Please note that this report address RFI points
1B, 1C, 1D, 1E, 1F, 1G, 2.1, 2.2, 3.2 & 3.3

RFI Response

Clonburris SDZ
November 2023

Proposed changes to streets to address RFI queries

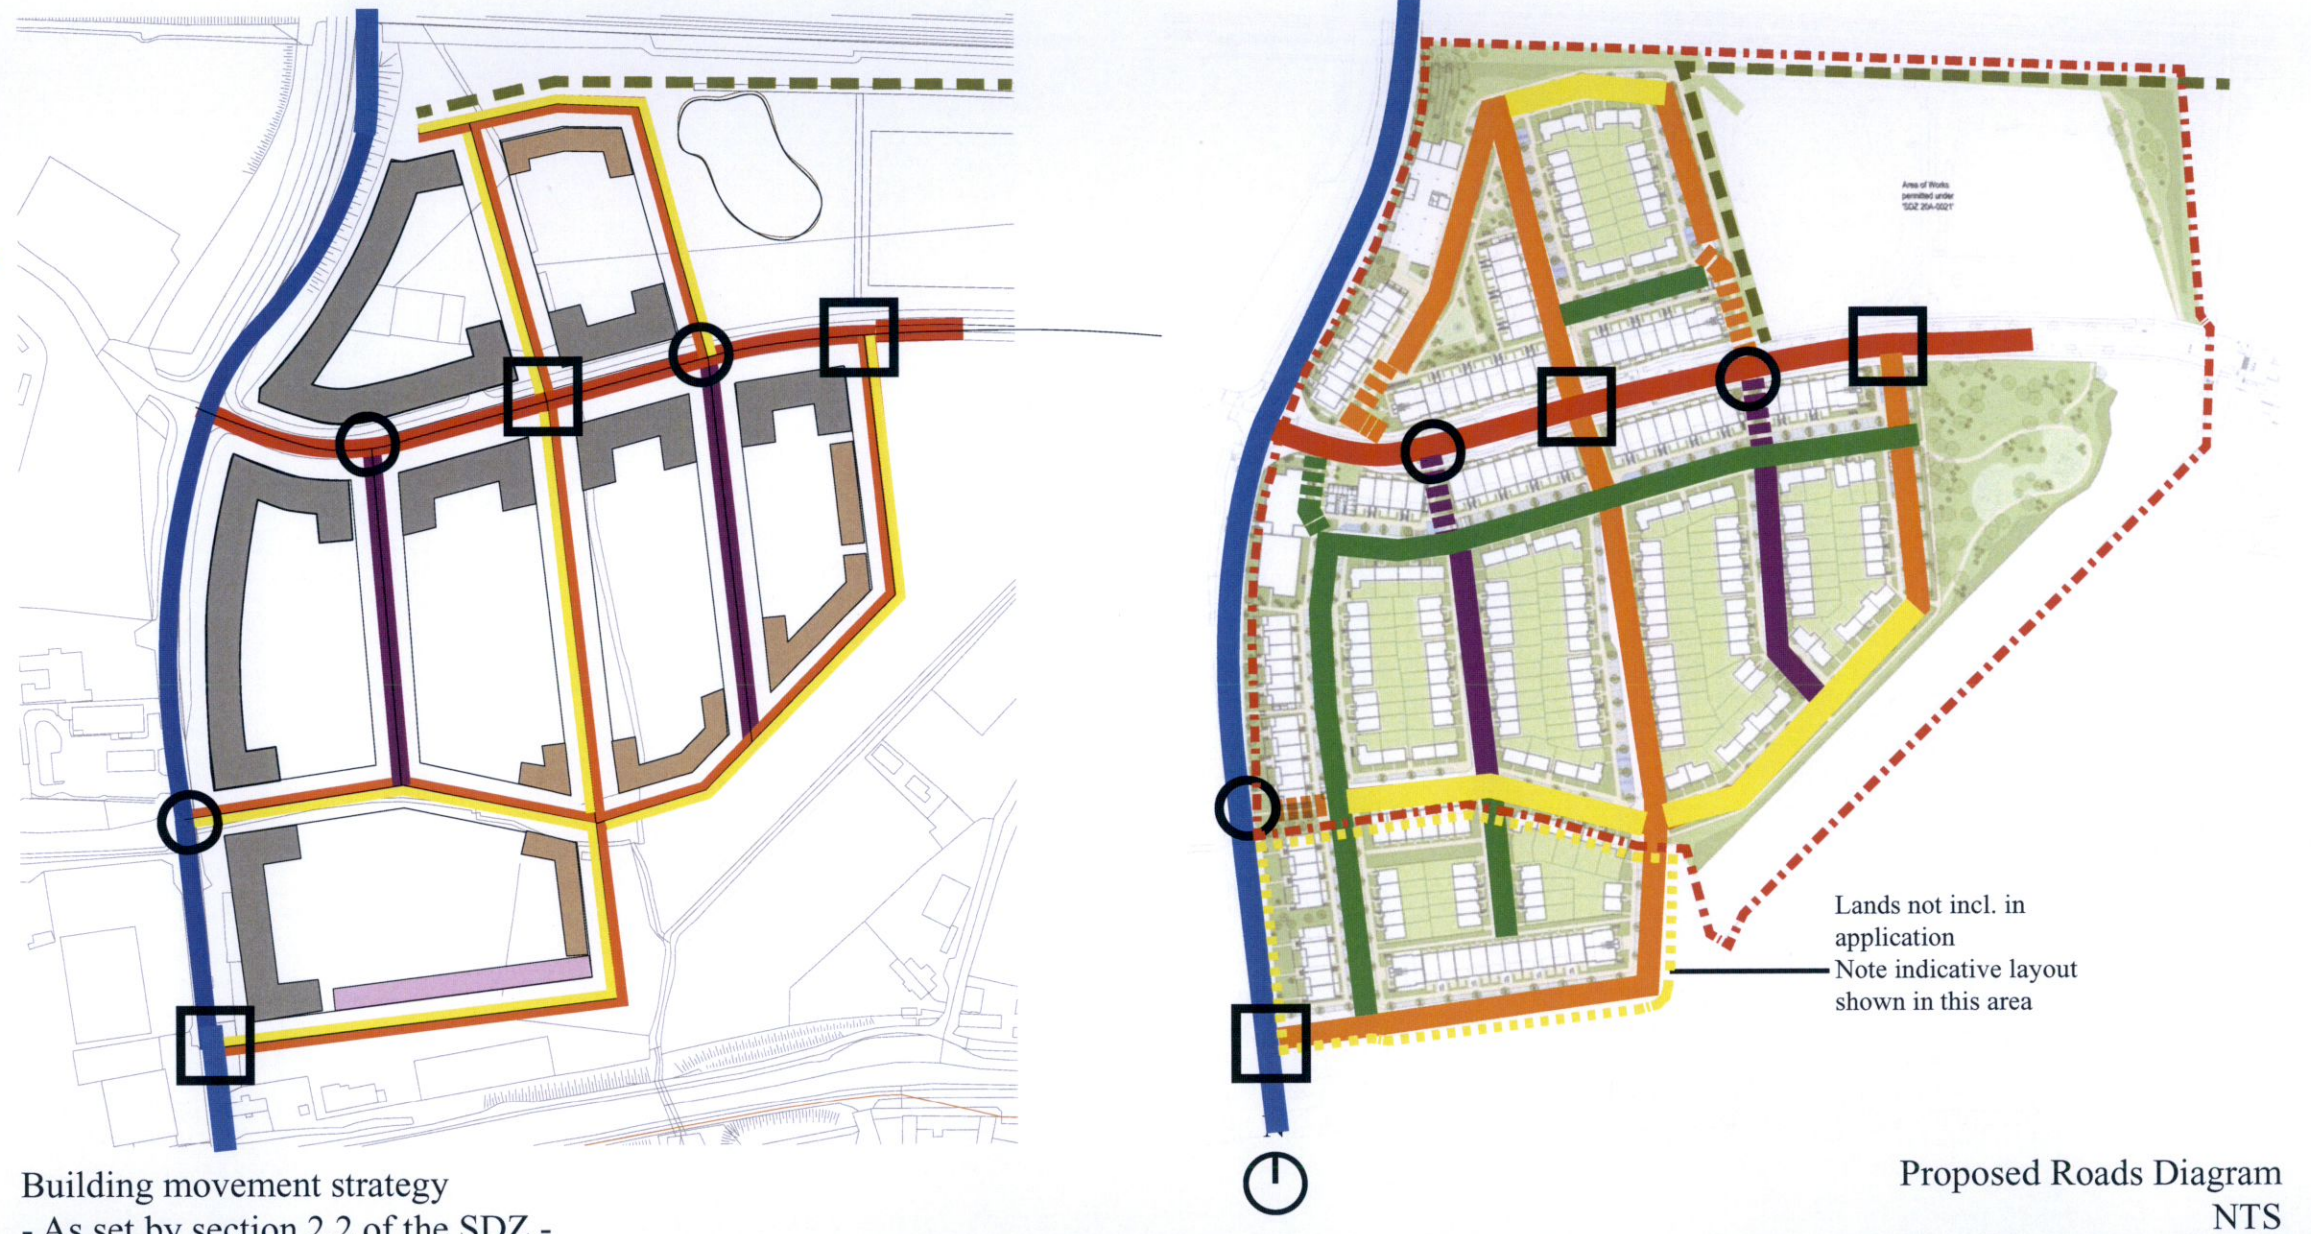
1E. Intimate Local Street 2:
South end of street widens to 22.6m between frontages with perpendicular parking. The applicant is requested to redesign this portion of the street to ensure in keeping with scheme road layout and requirements for intimate local streets.

2.2 The applicant is requested to revise plans to include additional street trees on local street 2,3,9,7. Currently only one side of street is planted.

Response:
In order to address points raised under RFI sections 1E and 2.2 - a number of changes have been proposed to street sections and street types across the plan. As requested additional street streets have been added to local streets 2, 3, 7 & 9. To achieve this the street profile has been adjusted to further match the SDZ. Local street 2 has been redesigned to use a Local Street Type B profile - which allows further street trees to be provided within the plan.

Intimate street 2 has been redesigned in line with the requirements of the SDZ street diagrams - along its full length.

Proposed Changes to local street 3

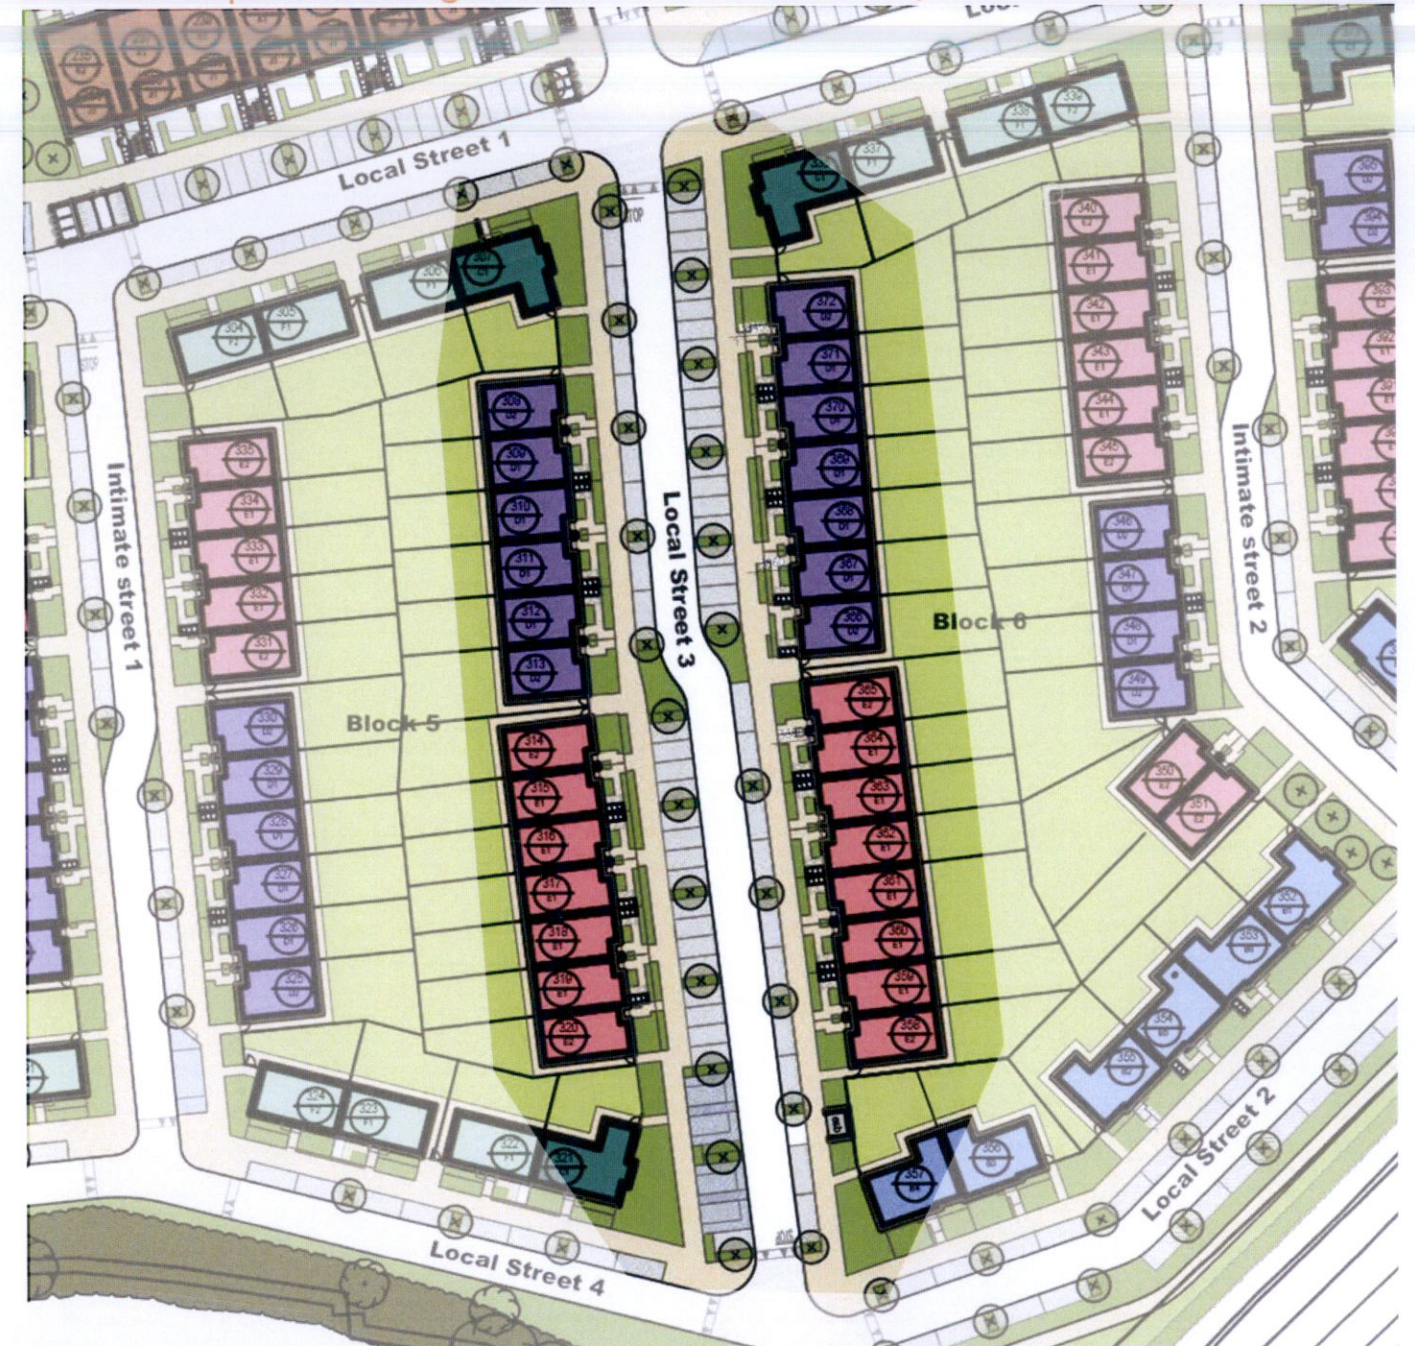
South end of street widens to 22.6m between frontages with perpendicular parking. The applicant is requested to redesign this portion of the street to ensure in keeping with scheme road layout and requirements for intimate local streets.

The south end of Intimate Street 2 has been amended to remove perpendicular parking - and now shows parallel parking to one side of the street only. The street profile in this location now matches the intimate street requirements set out in the SDZ. The positions of houses along this section of intimate street have been adjusted to ensure the maximum separation distances are not exceeded.

Proposed Changes to northern end of local street 2

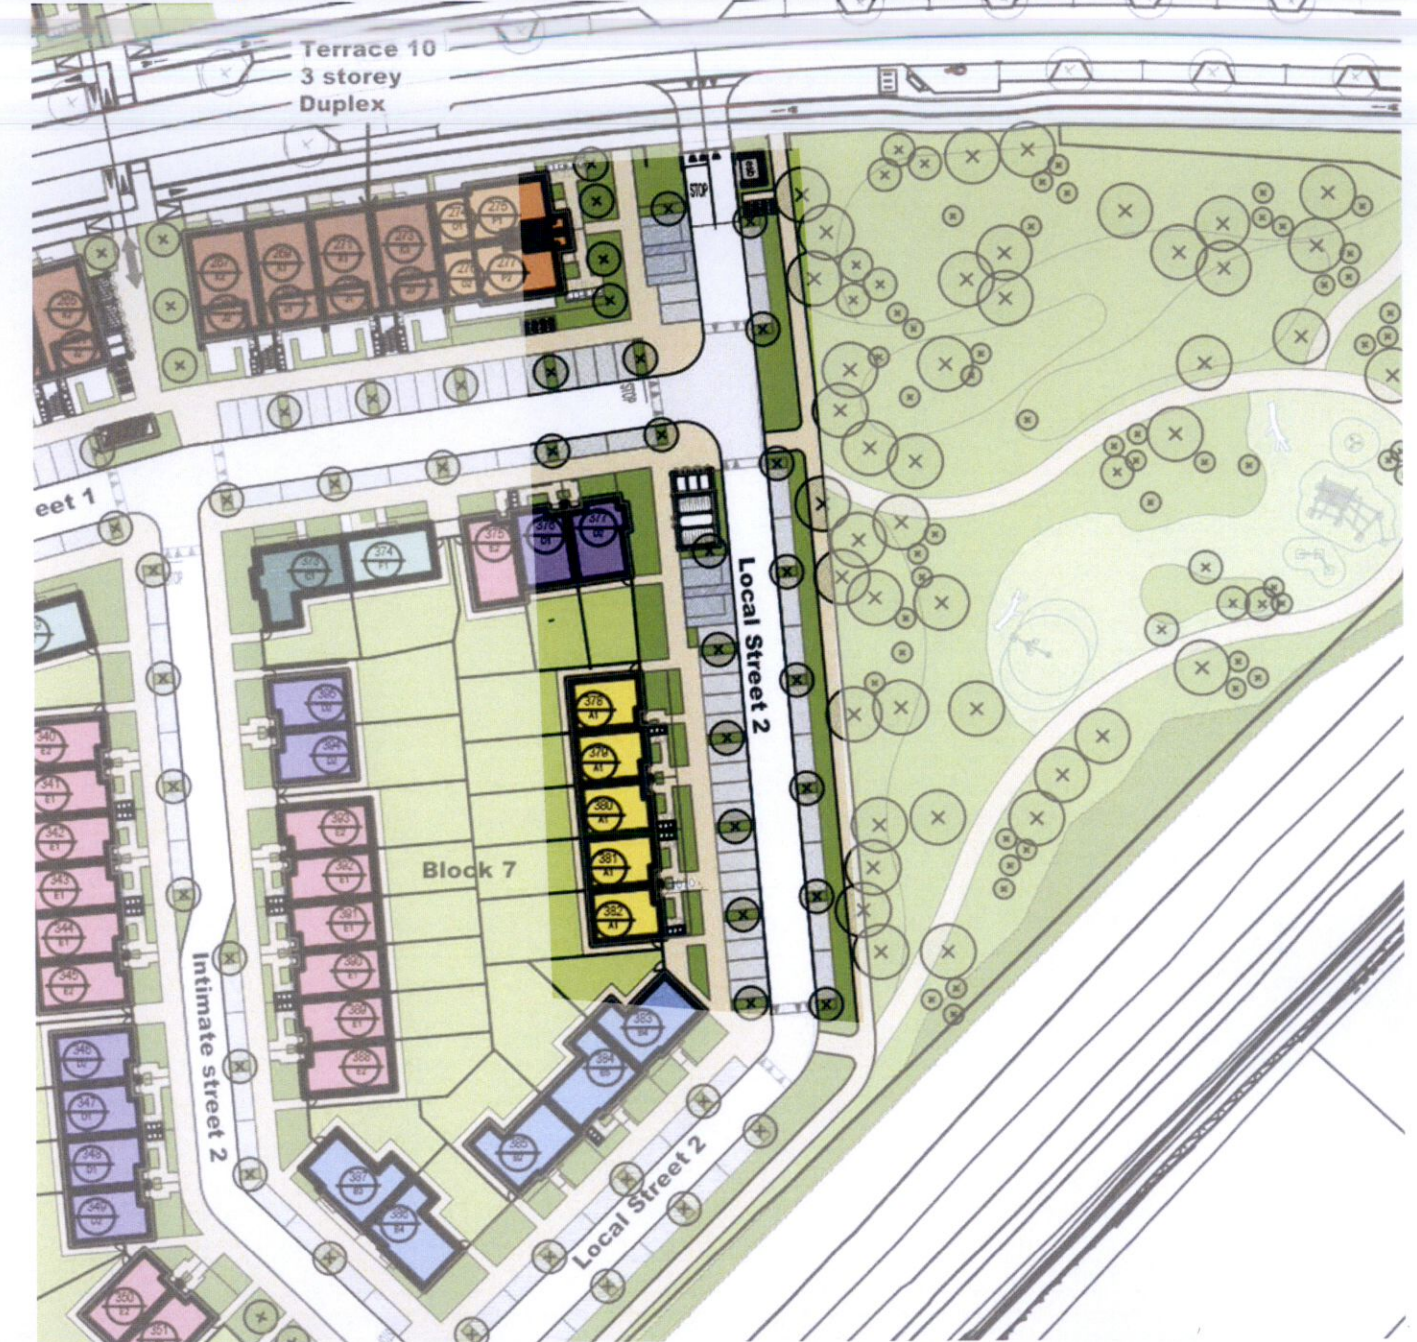
2.2. The applicant is requested to revise plans to include additional street trees on local street 2,3,9,7. Currently only one side of street is planted.

The street profile of Local street 2 has been redesigned to align with SDZ street diagrams. The footpath location has been amended to remove parking previously shown as in-curtilage now shown as within zone to be taken in charge. Perpendicular parking has now been replaced with parallel parking - in line with the SDZ defined Local Street type B. Additional street trees have now been added to taken in charge areas in accordance with SDZ diagram.
